CONSTRUCTION STAKE PLOT PLAN

ORDERED BY: KENNEY HOMES
DESCRIPTION: LOT 25, VILLAS AT MEADOWS AT SUMMIT RIDGE 12TH, PLAT IN LEE'S SUMMIT, MO
3329 SW JESSIE CIR.

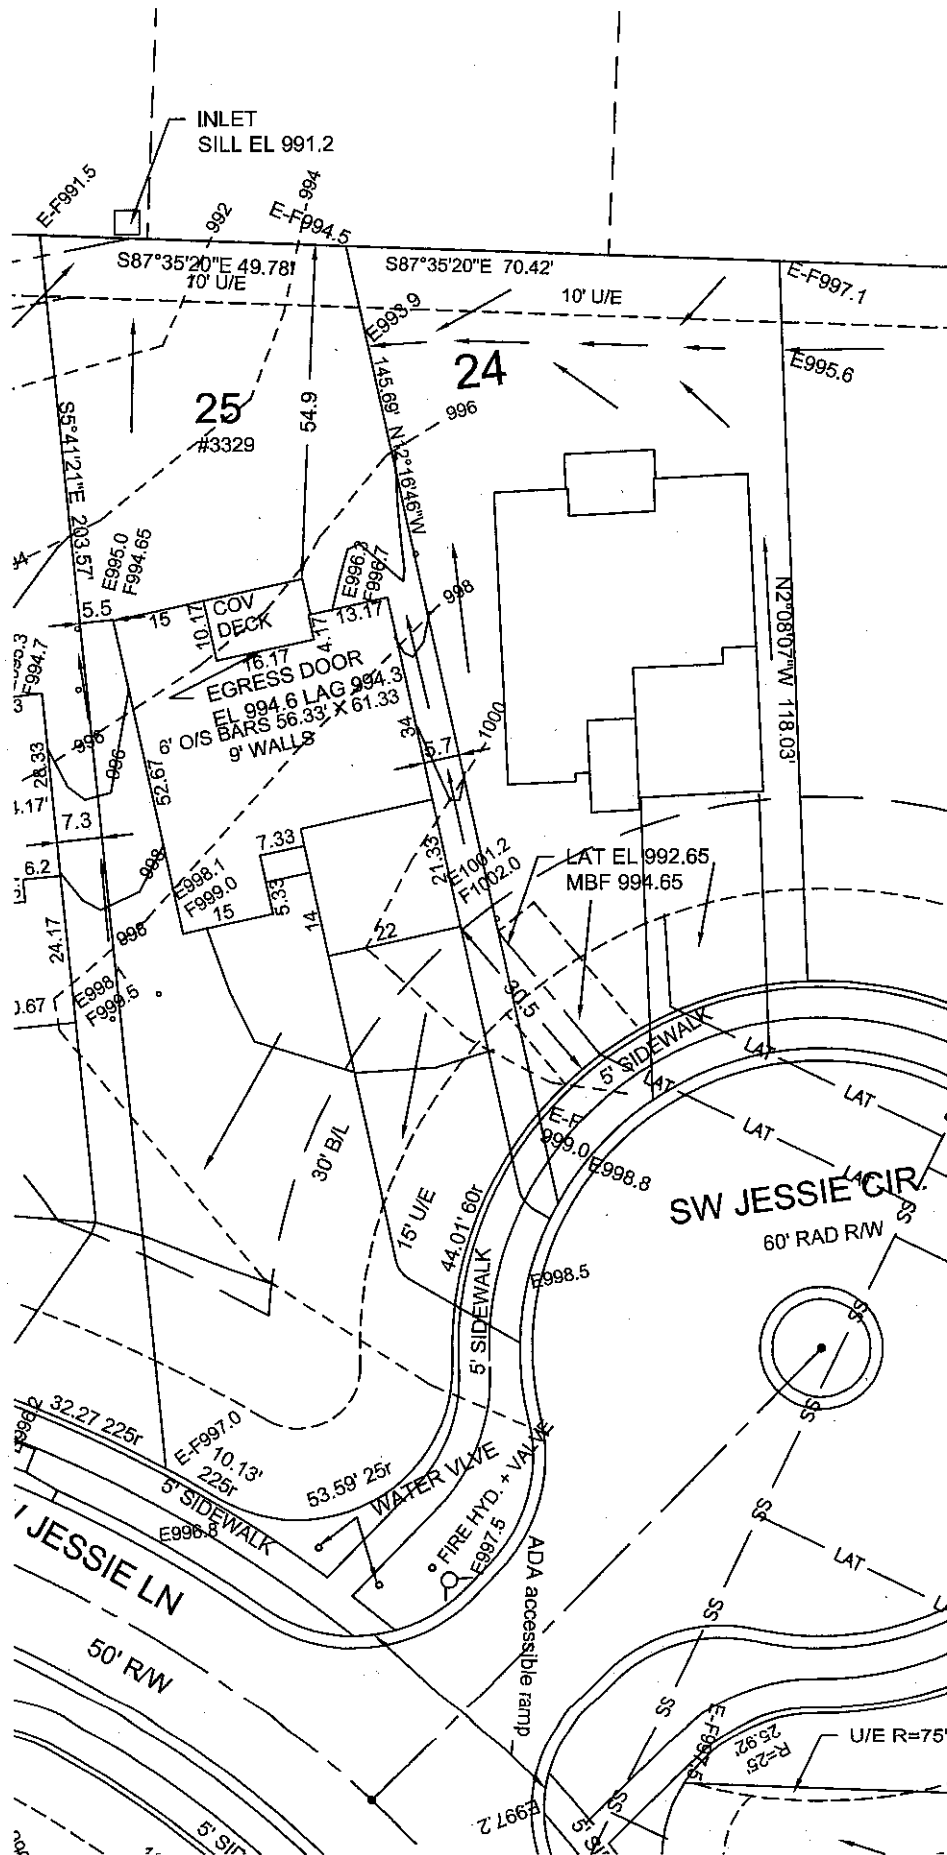
AS-GRADED PLOT PLAN
IS REQUIRED PRIOR
TO SODDING.

BUILDER TO EXPOSE LATERAL
AND CHECK DEPTH PRIOR TO
EXCAVATION FOR BASEMENT.
GRINDER PUMP MAY BE
REQUIRED.
